PIC16(L)F1933 Silicon Errata and Data Sheet Clarification

The PIC16(L)F1933 family devices that you have received conform functionally to the current Device Data Sheet (DS41575C), except for the anomalies described in this document.

Data Sheet Clarifications

FIGURE 1: INSTRUCTION CYCLE DELAY CALCULATION EXAMPLE

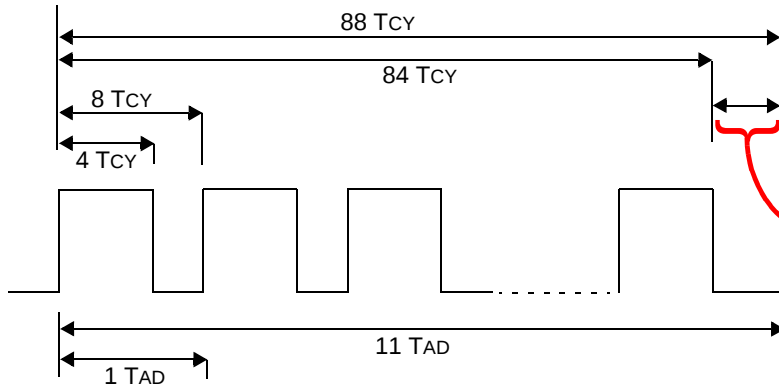
An ADC conversion may not complete under these conditions:

1. When Fosc is greater than 8 MHz and it is the clock source used for the ADC converter.
2. The ADC is operating from its dedicated internal FRC oscillator and the device is not in Sleep mode (any Fosc frequency).

When this occurs, the ADC Interrupt Flag (ADIF) does not get set, the GO/DONE bit does not get cleared, and the conversion result does not get loaded into the ADRESH and ADRESL result registers.

Method 3: This method is provided if the application cannot use Sleep mode and requires continuous operation at frequencies above 8 MHz. This method requires early termination of an ADC conversion. Provide a fixed time delay in software to stop the A-to-D conversion manually, after all 10 bits are converted, but before the conversion would complete automatically. The conversion is stopped by clearing the GO/DONE bit in software. The GO/DONE bit must be cleared during the last ½ TAD cycle, before the conversion would have completed automatically. Refer to [Figure 1](#) for details.

FOSC = 32 MHz
 TCY = 4/32 MHz = 125 nsec
 TAD = 1 µsec, ADCS = FOSC/32

Stop the A/D conversion between 10.5 and 11 TAD cycles.
 See the Analog-to-Digital Conversion Timing diagram in the Analog-to-Digital Converter chapter of the device data sheet.

In [Figure 1](#), 88 instruction cycles (TCY) will be required to complete the full conversion. Each TAD cycle consists of 8 TCY periods. A fixed delay is provided to stop the A/D conversion after 86 instruction cycles and terminate the conversion at the correct time as shown in the figure above.

FIGURE 5-4: CERAMIC RESONATOR OPERATION (XT OR HS MODE)

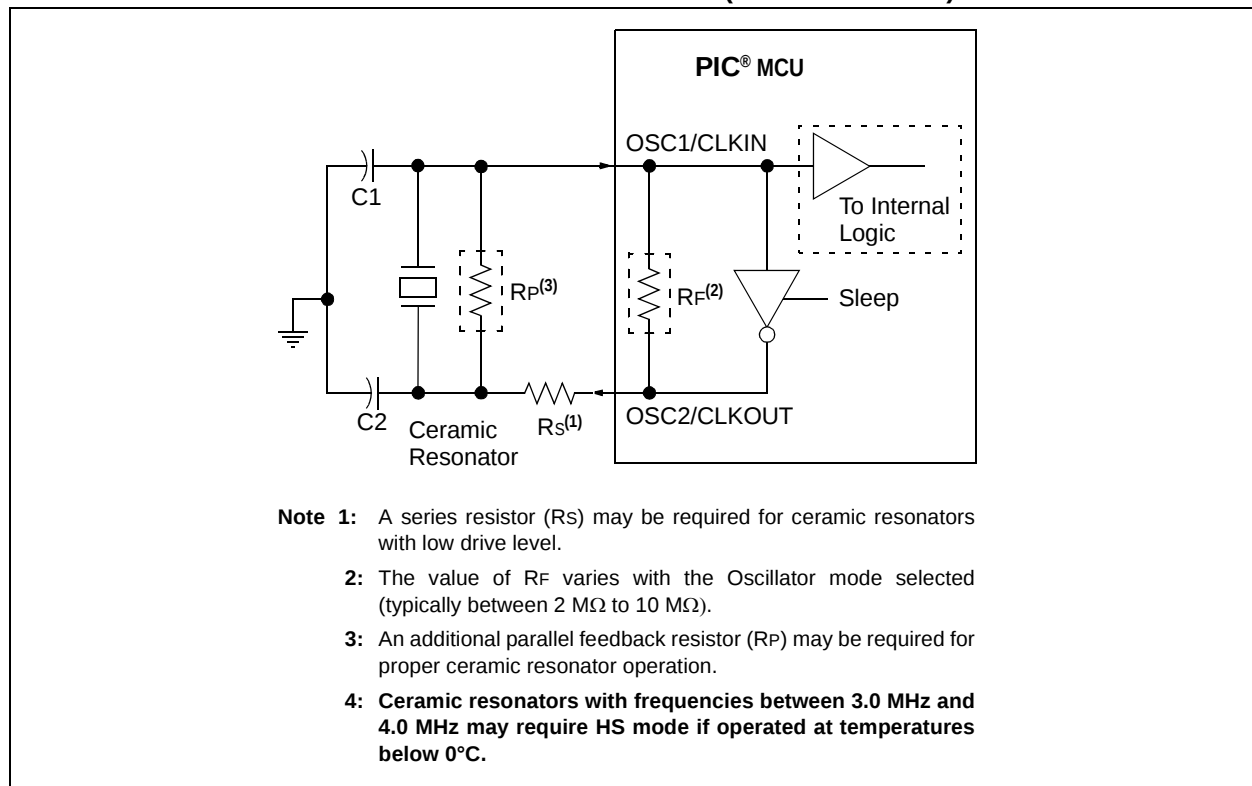
In [Figure 5-4](#), note 4 is added as following:
